**SYDNEY EASTERN CITY PLANNING PANEL  
SUPPLEMENTARY REPORT**

SECPP No	PPSSEC-23
DA Number	DA-2019/385
Local Government Area	Bayside Council
Proposed Development	Construction of a building for student accommodation ranging between seven (7) to twelve (12) storeys in height, and including four hundred and thirty-five (435) bedrooms and associated landscaping
Street Address	6-8 John Street and 13B Church Avenue Mascot
Applicant	Iglu No. 211 Pty Ltd c/- Mecone
Owner	Iglu No. 211 Pty Ltd
Number of Submissions	<p><u>Round One:</u> 137 submissions (including 35 individual submissions and 102 pro-forma letters)</p> <p><u>Round Two:</u> 160 submissions (including 66 individual submissions and 94 pro-forma letters)</p>
Regional Development Criteria (Schedule 7 of the SEPP)	Development with a CIV of \$59,697,000.00
List of All Relevant s4.15(1)(a) Matters	<ul style="list-style-type: none"> <li>○ Environmental Planning &amp; Assessment Act 1979, Part 4 – Development Assessment &amp; Schedule 7 of the SEPP- State and Regional Development 2011 which regional panels may be authorised to exercise consent authority functions of councils</li> <li>○ Environmental Planning &amp; Assessment Regulatio

**Figure 1. Proposed Basketball Court with notes relating to acoustic measures**

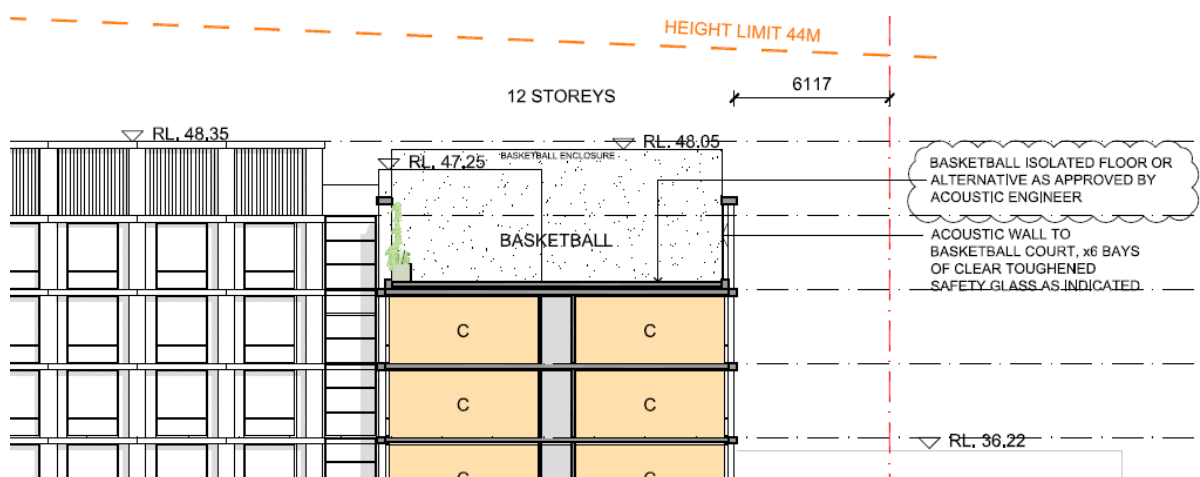
Concern was initially raised by the Panel relating to the acoustic treatment of the communal open space areas at the rooftop. The areas in question are the basketball court and open space area on the rooftop of Level 10 on the northern side of the development and the rooftop terrace on top of Level 7 on the southern side of the development.

On the applicant's amended plans, the rooftop of Level 10 has generally been amended to address the Panels concerns. The applicant has removed the landscaped area and replaced this with solar panels which assists in providing greater sustainability measures to the development as well as creating a non-trafficable area where occupants do not have access to. This results in a smaller amount of COS within the development and usability of the rooftop.

A note has been made on the basketball court, shown in Figure 1 below, that an isolated floor or alternative as approved by an acoustic engineer is to be provided. The applicant has not provided a revised acoustic report as part of the amended set of documentation. Council had previously imposed a draft condition of consent relating to acoustic treatment. This condition is to be amended to make specific reference to a sound insulated floor treatment on the basketball court to reflect the plans and details and validation is to be provided prior to the issue of the Construction and Occupation Certificate.

*Prior to the issue of the Construction Certificate, the Acoustic Report prepared by Acoustic Logic dated 9 April 2020 is to be amended to include acoustic details of the rooftop basketball court. The report is to include an assessment of soundproof/isolated floor of the basketball court or an alternative recommended by a qualified acoustic engineer, in addition to acoustic wall/screening. Details of the provisions must be provided on the Construction Certificate plans submitted to the Principal Certifier prior to the release of a Construction Certificate. A copy of the amended acoustic report is to be provided to Council.*
